## York Region Standard Condominium Corporation # 972 and #1008

### REPORT TO COUNCIL – CITY FILE:OPA-23-2003

May 8, 2023

# DEVELOPMENT APPLICATION SUMMARY

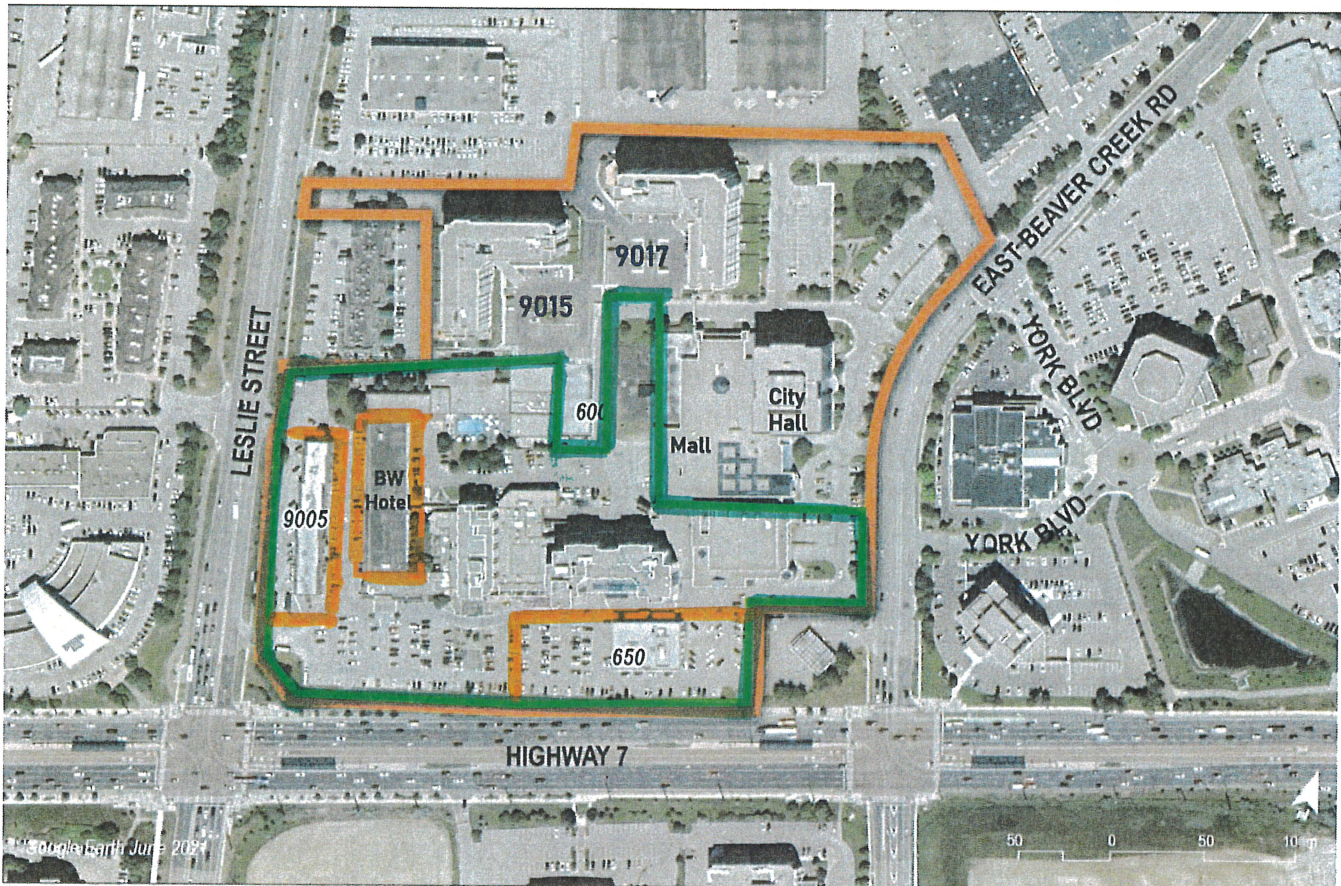
Actual Land

1. "Subject Land" as referred to in the Application:

- NOT 8.63 ha. as it wrongfully includes the lands belonging to the 2 condo buildings, City Hall and Parkway Mall.
- Should be 5.05 ha. (ie. area within green boundary)

2. Developable Land – only 1.54 ha

- Land made available after demolition of (a) Best Western Hotel (0.5 ha), 9005 Leslie St. (0.38 ha) and 650 Hwy 7E (0.66 ha). Buildings shown inside the dotted boundary lines should be treated as INFILL development, not redevelopment of whole site.
- Land size is too small to be designated a Key Development Area.

3. FSI (Floor Space Index) Formula = Total built-up area (existing and new) divided by Total Area of the Plot.

- The Application shows 5.55 FSI. This is INCORRECT as it includes only the GFA (Gross Floor Area) of the new builds and does not include the GFA of the existing Sheraton hotel, conference centre, retail shops, and Health Club.
- The actual FSI would be significantly higher than 5.55 FSI.
